**HORIZONTAL DIRECTIONAL DRILL ANALYSIS  
GOLDFINCH LANE CROSSING  
PADEP SECTION 105 PERMIT NO.: E11-352  
PA-CA-0016.0000-RD and PA-CA-0016.0000-RD-16  
(SPLP HDD No. S2-0069)**

This reanalysis of the horizontal directional drill (HDD) of the Sunoco Pipeline, LP (SPLP) 16-inch and 20-inch diameter pipeline crossing of streams S-N41 and S-N42 (both unnamed tributaries to Hinckston Run), Wetlands N25, N26, and N27, and Goldfinch Lane in Jackson Township, Cambria County, is in accordance with Stipulated Order issued under Environmental Hearing Board Docket No. 2017-009-L for HDDs listed on Exhibit 2 of the Stipulated Order. This HDD is number 5 on the list of HDDs included on Exhibit 2. This HDD was not initiated before the issuance of the Order.

It is SPLP’s intent to modify the original profile design and to pursue a deeper and longer HDD profile. Figure 1 and 3 in Attachment 3 presents the original HDD plan and profiles. Figure 2 and 4 in Attachment 3 present the revised HDD plan and profiles.

PLAN VIEW

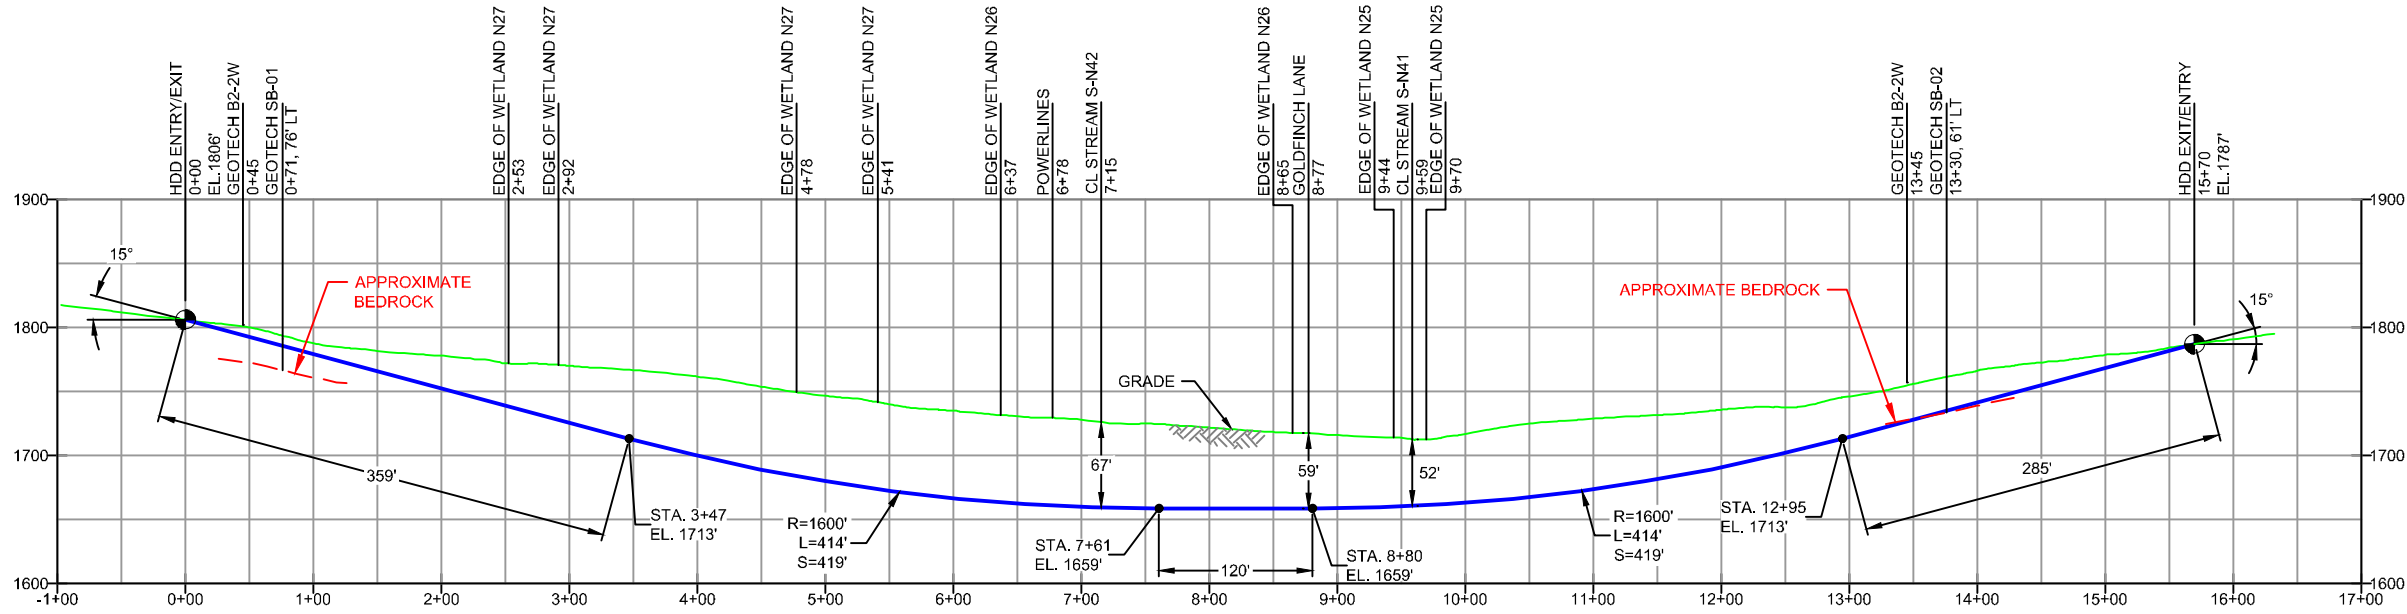
As shown on Figure 2, the redesigned HDD profile for the 20-inch pipeline is 237 ft longer, with a depth of cover below the streams and wetlands increased by 25-30 ft from the permitted design. In addition, the entry/exit angles have been increased allowing for a sharper and quicker descent into more competent rock. As shown on Figure 4 the redesigned HDD profile for the 16-inch pipeline is 99 ft longer, with a depth of cover below the streams and wetlands increased by 19-21 ft and designed for a sharp and quick entry and exit from the horizontal depth.

- Horizontal length: 1,545 foot (ft)
- Entry/Exit angle: 15-16 degrees
- Maximum Depth of cover: 60 ft
- Depth under Goldfinch Lane: 39 ft
- Depth under streams: 34-48 ft
- Depth under wetlands: 34-50 ft
- Pipe design radius: 2,000 ft

- Horizontal length: 1,570 foot (ft)
- Entry/Exit angle: 15 degrees
- Maximum Depth of cover: 67 ft
- Depth under Goldfinch Lane: 59 ft
- Depth under streams: 52-67 ft
- Depth under wetlands: 52-70 ft
- Pipe design radius: 1,600 ft
